CITY PLANNING COMMISSION

- APPLICATION:**
1. Environmental Determination
 2. Rezone from Agricultural (A) to Single Family (R-1)
 3. Tentative Map (P83-355)

LOCATION: East side of Park Riviera Way at the northerly terminus of Spurlock Way

PROPOSAL: The applicant is requesting the entitlements necessary to divide 7± acres with four existing residences into 24 single family lots.

TENTATIVE MAP

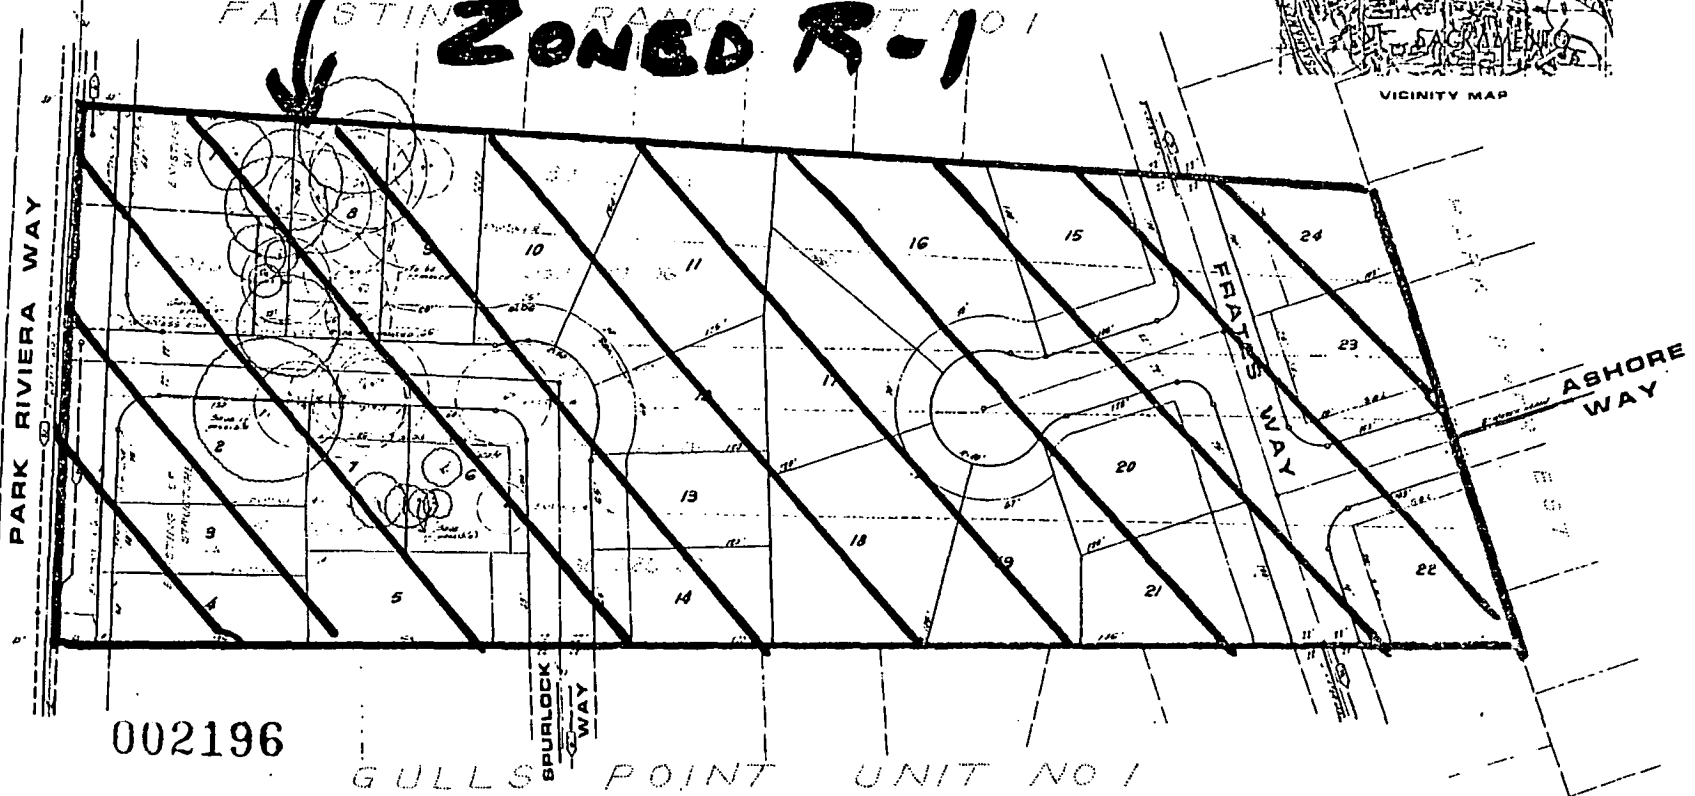
8. Incorporate Lot A into N.A.P.O.T.S. parcel or merge with Lot 8;
9. Remove all structures located on individual lots crossing lot lines and all non-residential structures on parcels;

Approximately 15 of 31 on-site trees are proposed to be removed. The City Arborist has no objection to the removal of these trees as most of these trees consist of Modesto Ash and plum trees. To insure the retention of the remaining on-site trees, staff recommends that the necessary notes and conditions be placed on the tentative map.

- g. Incorporate Lot A into N.A.P.O.T.S. parcel or merge with Lot 8;
- h. Remove all structures located on individual lots crossing lot lines and all non-residential structures on parcels;

- i. Place the following note on the final map: The existing trees (as noted on the tentative map to be retained) shall be retained unless prior approval is obtained from the Planning Director or City Arborist;
- j. Locate all septic tanks and leach lines and abandon as required by County Health;
- k. Provide sewer and water service and hookup for existing residences;
- l. The proposed residence to be removed shall be relocated unless prior approval for its demolition is obtained from the Planning Director.

Possible Alternative Subdivision
Given R-1 Zoning

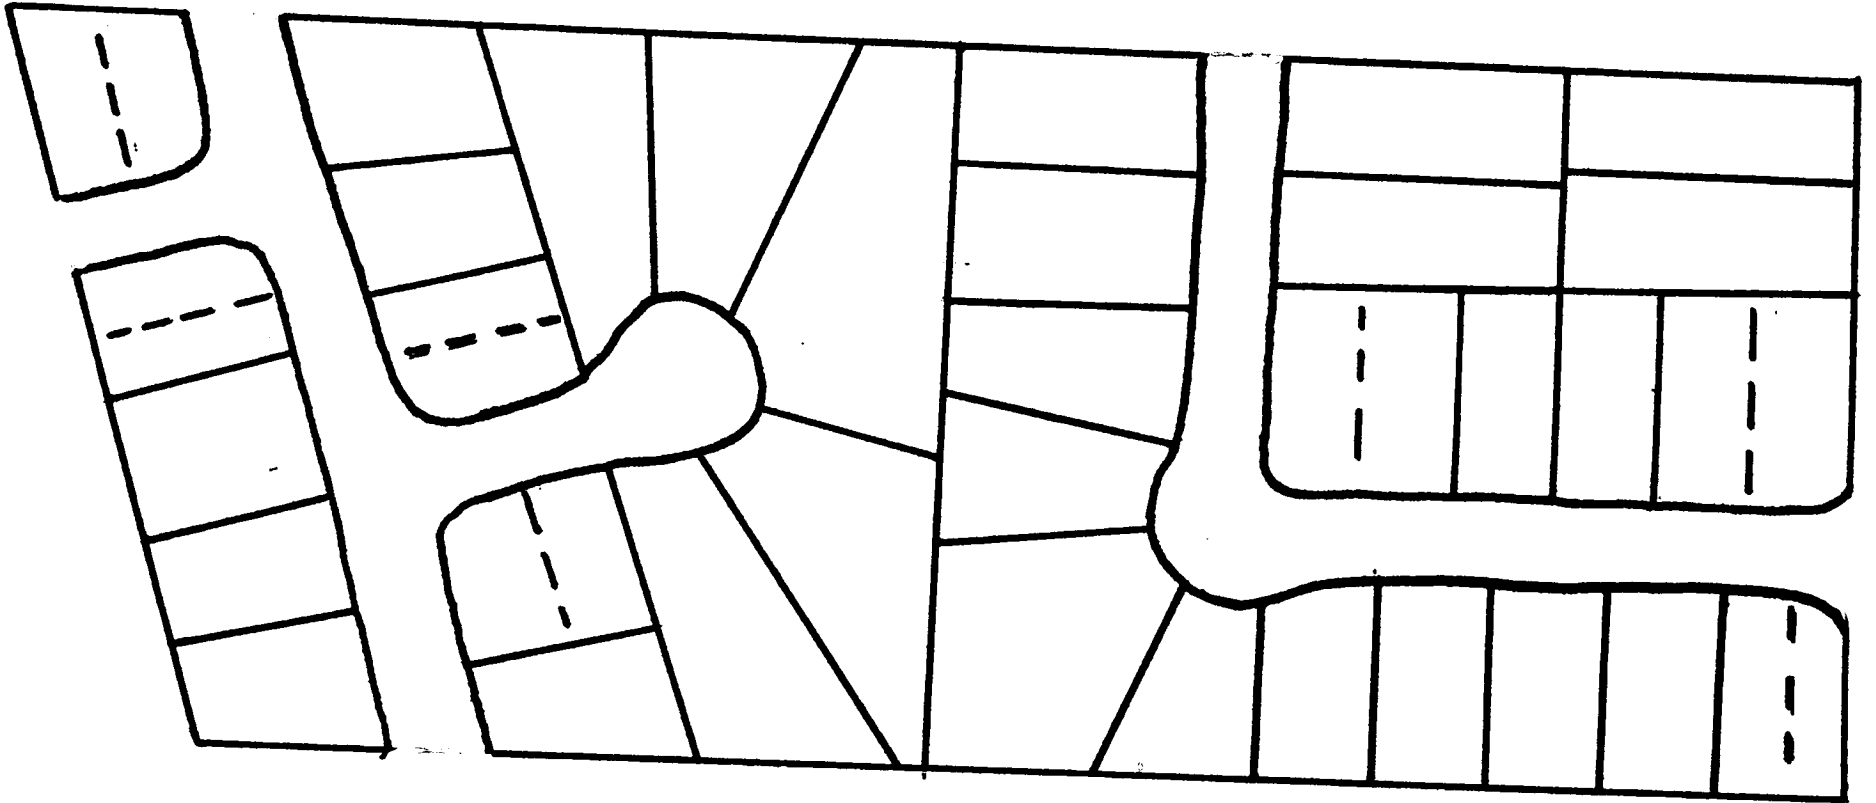
1. The North Pocket specific plan designates the subject site as residential, 4-6 dwelling units per gross acre. Per this designation 44 dwelling units would be permitted per a standard single family subdivision of the site. For comparison purposes staff has prepared exhibit M which indicates a likely subdivision of the site which provides for 41 dwelling units.
